Our Town Hall

Metrolink OLE Column justification

OTH-ARU-ZZ-ZZ-RPT-B-0049 | P03 | 5 November 2020

Figure 4 - Example of Metrolink OLE columns on St Peters Square, which were designed with flat-panel LED streetlighting luminaires installed

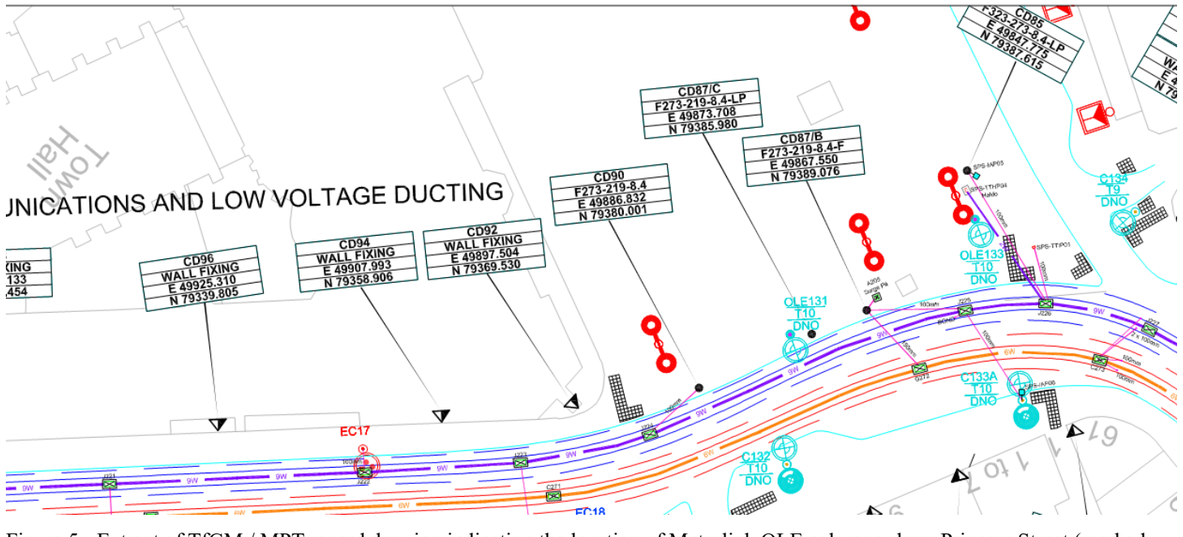
OLE columns are provided along both sides of the pavement of Princess Street. A query was raised by the LPA as to whether luminaires could be mounted to the OLE columns to provide some of the required lighting to Albert Square instead of from the lighting totems. An example of hybrid OLEs is shown in Figure 4.

Figure 10 - Revised public realm lighting proposals

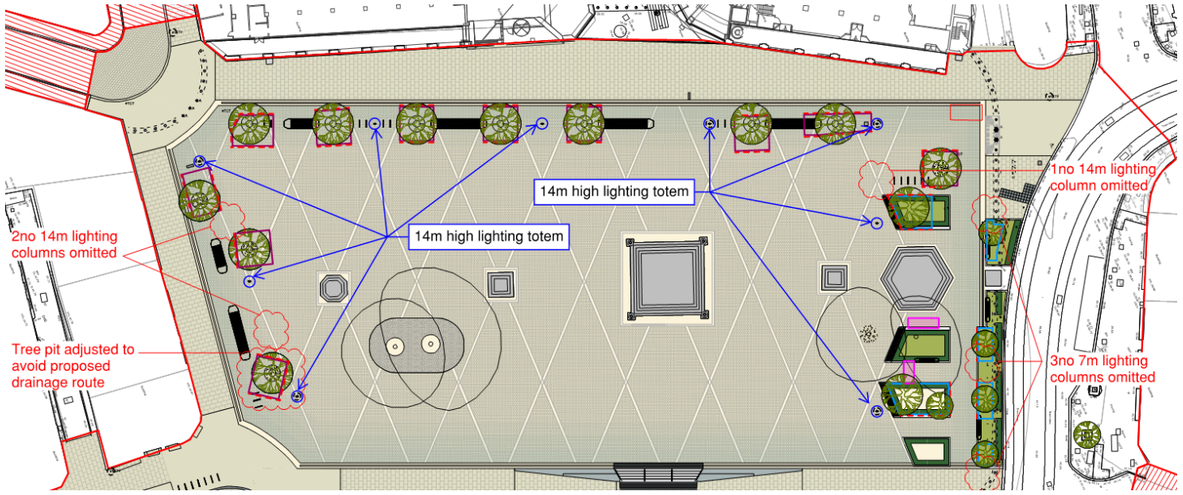
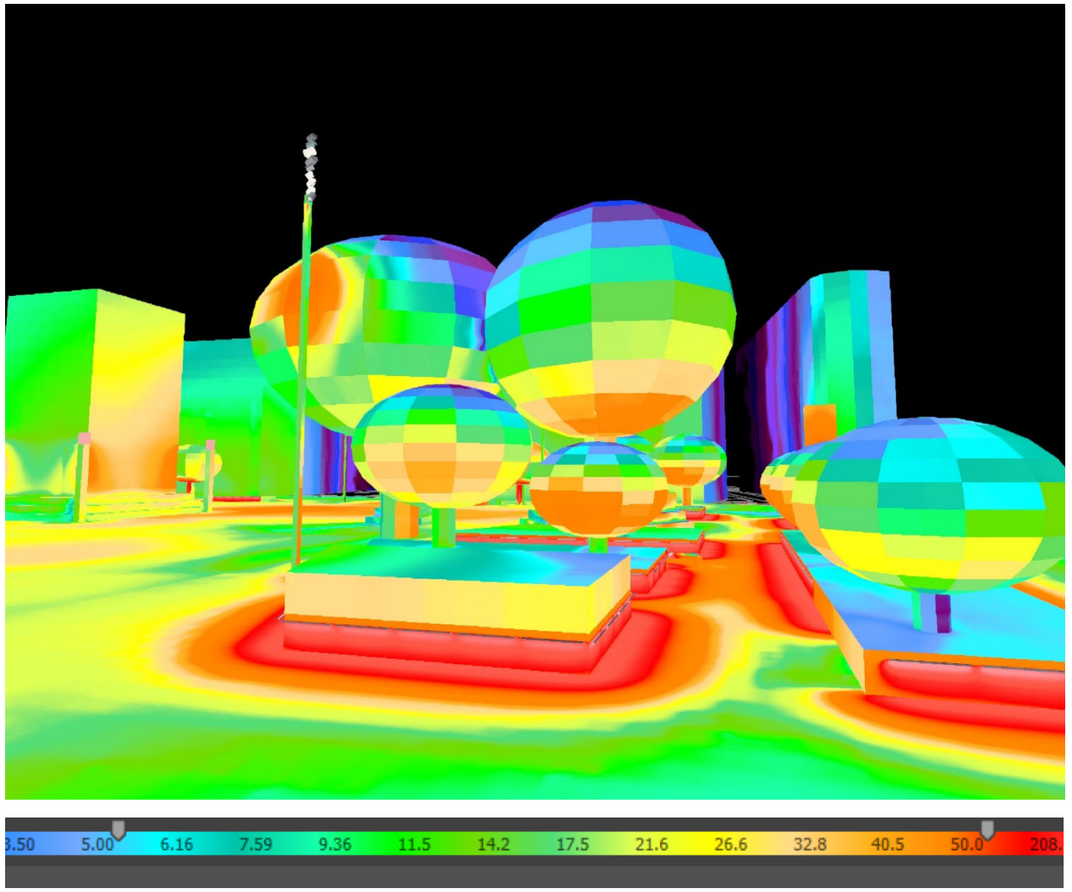
Following the comments from the LPA, the Our Town Hall project design team have been looking into options for reducing visual 'clutter' on Albert Square and further rationalising the scheme. As part of this, Arup have identified the opportunity to reduce the quantity of lighting totems on Albert Square in the following ways;

- Relocating some of the 14m high totems to bring them in line with the trees
- Omitting the three 7m high totems along Princess Street by using additional low-level illumination in the planters/furniture and relocating the luminaires on the 7m totems to the nearby 14m totems.
- Removal of two 14m totems along the Lloyd Street side of the square by relocating the luminaires from these onto the remaining three 14m totems.

Incorporating these alterations means that Arup do not feel that there is any requirement to provide lighting to the Metrolink OLE columns, and the main intention of the Planning Condition was to reduce the visual clutter which will be achieved with the changes implemented above.
